**TOWN OF GRANITE QUARRY
PLANNING BOARD
REGULAR MEETING AGENDA
March 6, 2023
6:00 p.m.**

**Rezoning 066 047
RL & OI to CD-PUD**

Subject: CD-PUD (Conditional District-Planned Unit Development)
Case #: ZO-23-02
Project Address: TBA N Salisbury Ave./Stokes Ferry Rd.
Project Tax Parcel#: 066 047
Property Owners: Florence Sifford Heirs
Applicant: Belle Realty Development Inc. (Wallace Realty)
Current Zoning: RL (Residential Low Density) & OI (Office & Institutional)
Action Date: Planning Board- March 6th, 2023
Request: Rezone from RL & OI to CD-PUD with Site Plan

Project Name: "Sifford" PUD Subdivision **Revision**

RZ-1

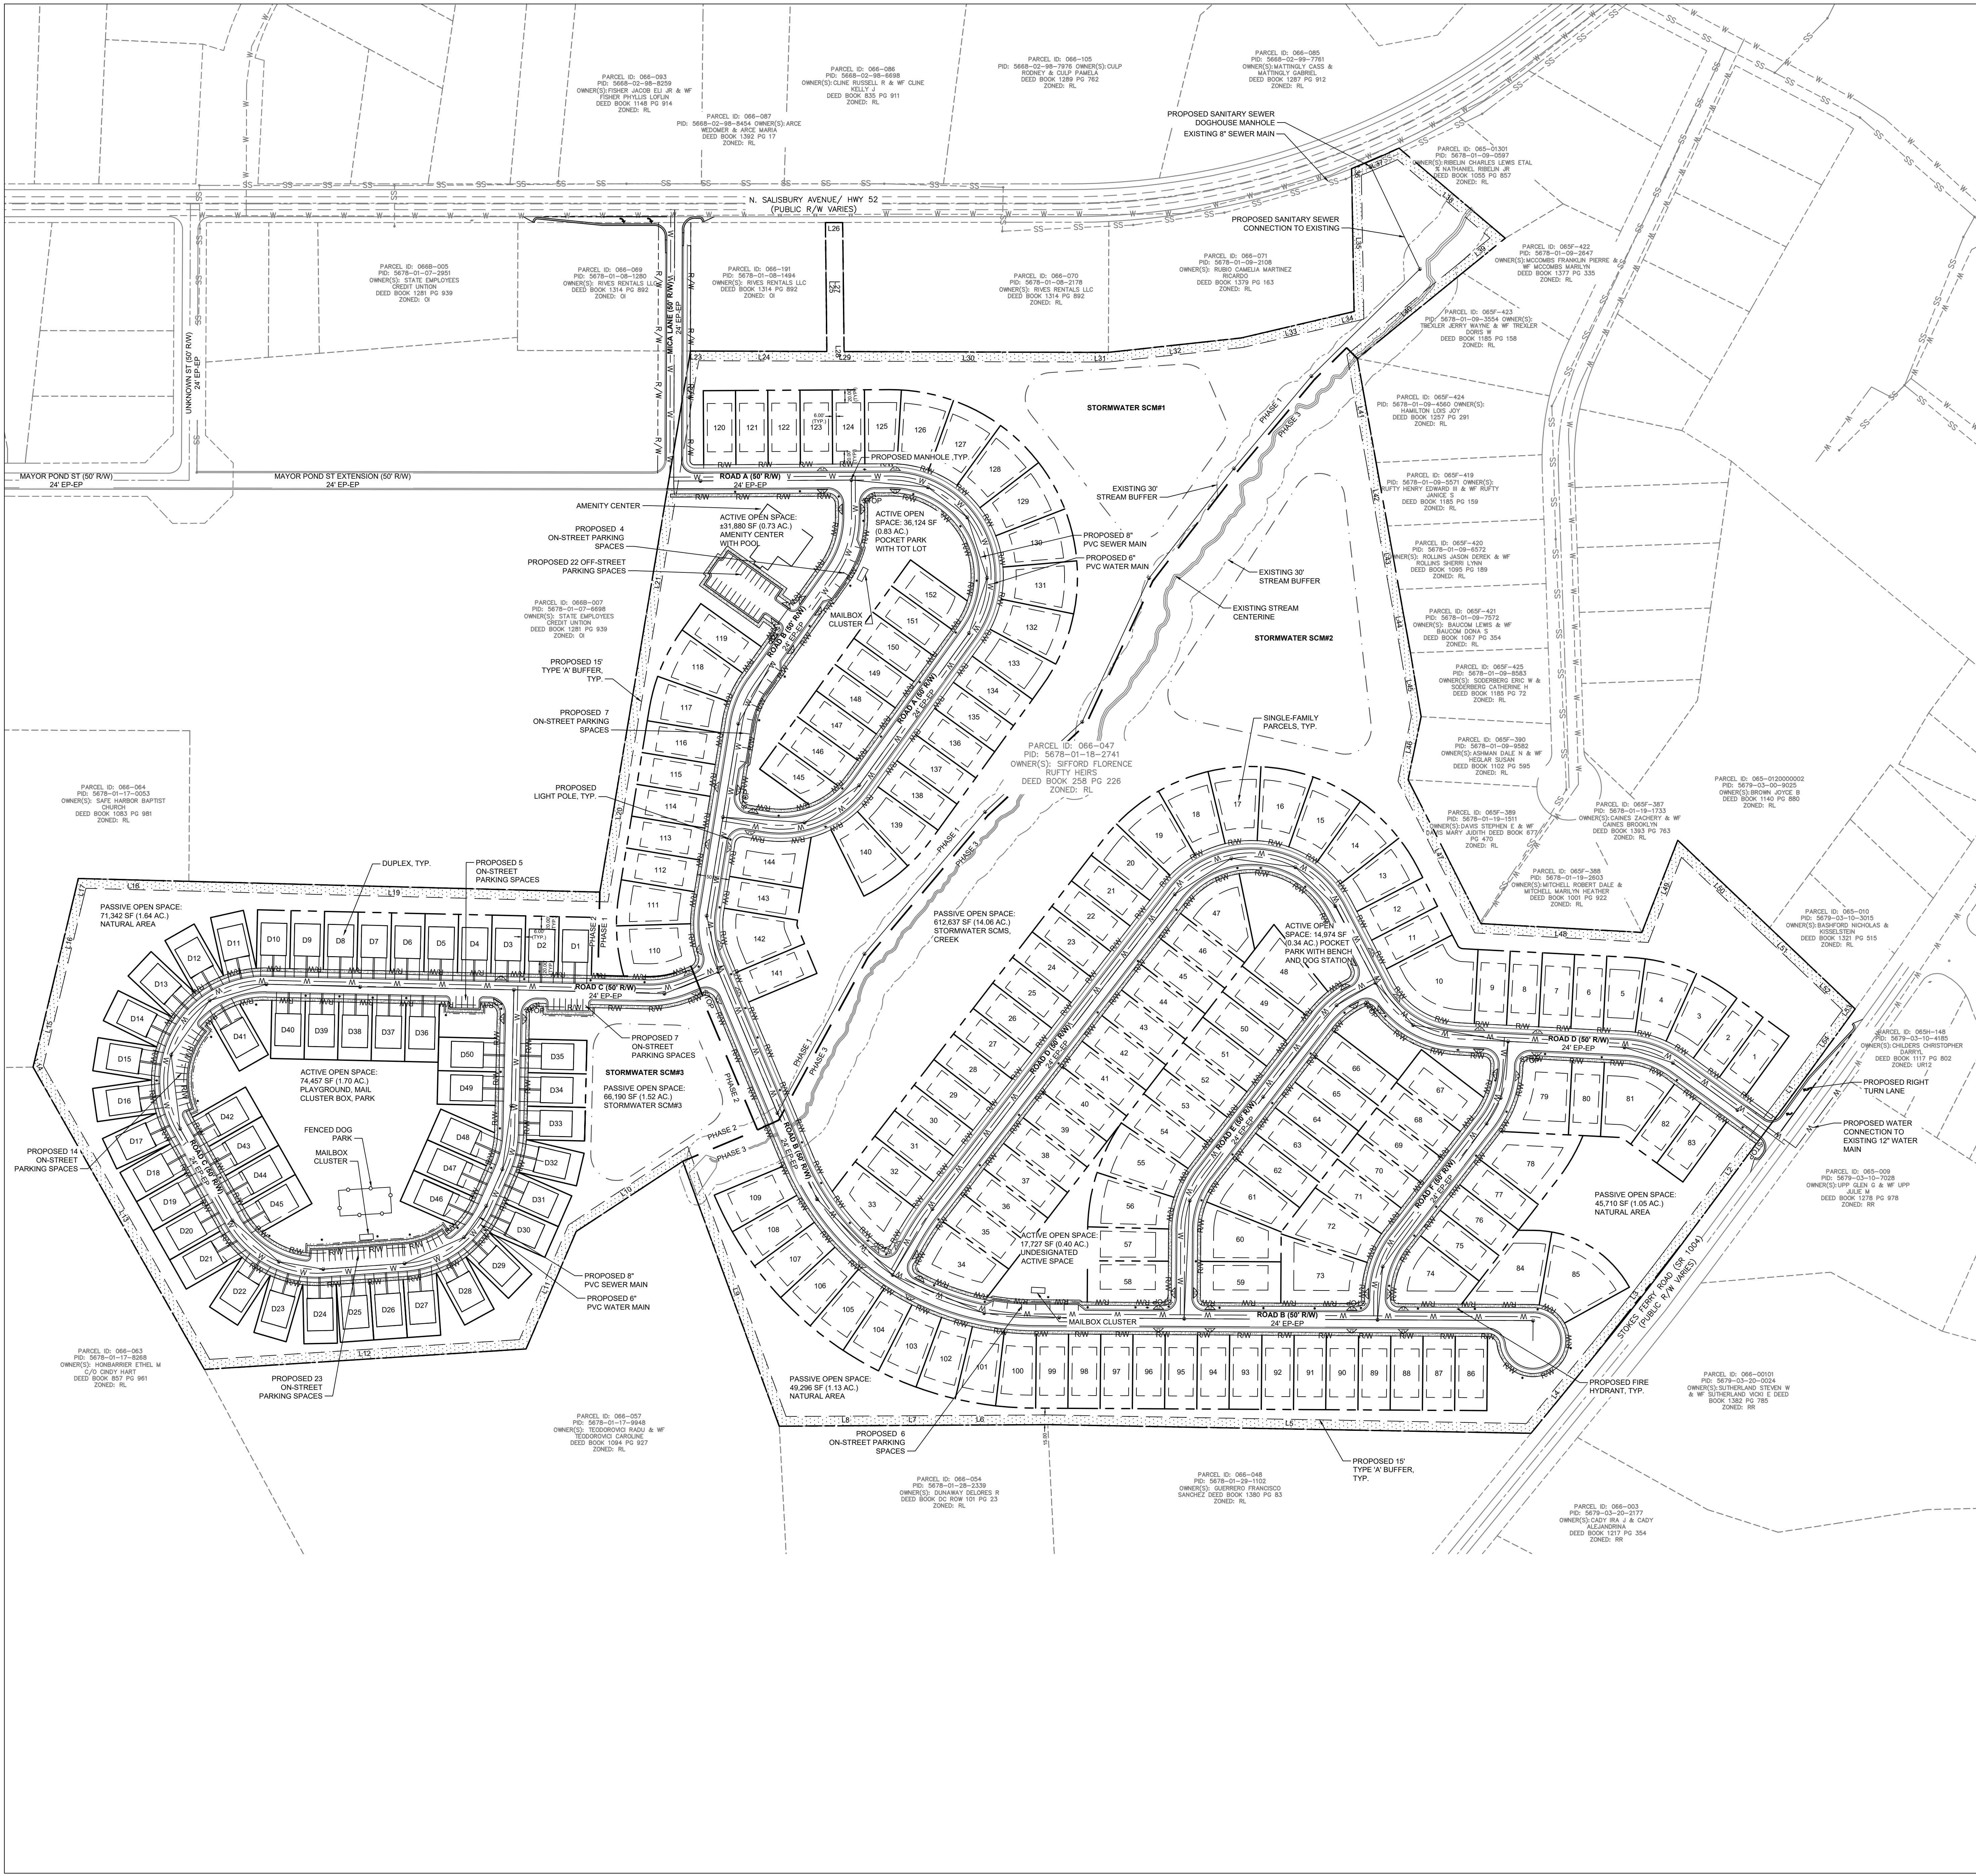
1. Could water line be moved to shoulder of Mica Lane to avoid disturbing existing pavement?
2. Sewer outfall will require 30' utility easement. The embankment for SCM#1 must be completely outside of this easement.
3. Provide sewer stub and easement from Road B to the property line in the vicinity of Lot 108 for future extension. A water stub will also be required in the same location and could share a 40' utility easement.
4. Onsite water and sewer do not meet minimum separation. Water may be moved to the shoulder (grass strip) as long as street trees are not proposed.
5. Utility plan review and permitting will be required through City of Salisbury. Please contact the City's Development Services "One-Stop Shop" at 1stop@salisburync.gov or 704-638-5208.

- The typical street layout dimensions need to be confirmed. The typical features shown on the street detail will not fit within a 50 foot right of way. Please note that the minimum sidewalk width is 5 feet. Remove the 4 foot label in the key chart. An area with a minimum width of one foot wide should be provided between the edge of sidewalk and any cut or fill slopes.

- Label any areas where valley curb will be installed (if any) and provide a typical street detail if used.
- The intersection of Road D may have sight distance issues with the connection to Road B. There may need to be additional site improvements or restrictions provided once the construction plans are reviewed.

- The plans have ADA ramps and what appear to be sidewalk lines on both sides of all roads, so it is assumed that sidewalks will be provided on both sides. The hatch for sidewalk is only shown on one side of the road for sections of Road A Road B, and Road D. This needs to be shown on the typical street details. **On Sheet RZ-1, the hatch is still missing on one side of the road for serval streets. Please note that the typical detail showing sidewalk on both sides of the road will be used for review, unless sidewalk reductions are included in the site plan approval conditions.**

6. Storm drainage structures will need to be constructed at intersections and along the road. The driveway layouts for ~~townhomes~~ duplex lots and houses will need to provide room for the construction of NCDOT curb inlets (and the 10 foot transition between curb inlets if a valley curb profile is used).

12. The typical detail provided for the duplex has only has one 18' wide driveway labeled with a width that will accommodate 2 vehicles. The typical detail and the layout on Sheet RZ-1 appear to show two driveways being constructed on each lot, which is likely needed to meet the requirements for the minimum number of parking spaces. The duplex layout shown on Sheet RZ-1 also appears to conflict with the requirement for 25' between duplex driveways listed in Section 22-32. If only one 18' wide driveway is constructed, the layout will comply with the ordinance standard for the minimum dimensions between driveways.
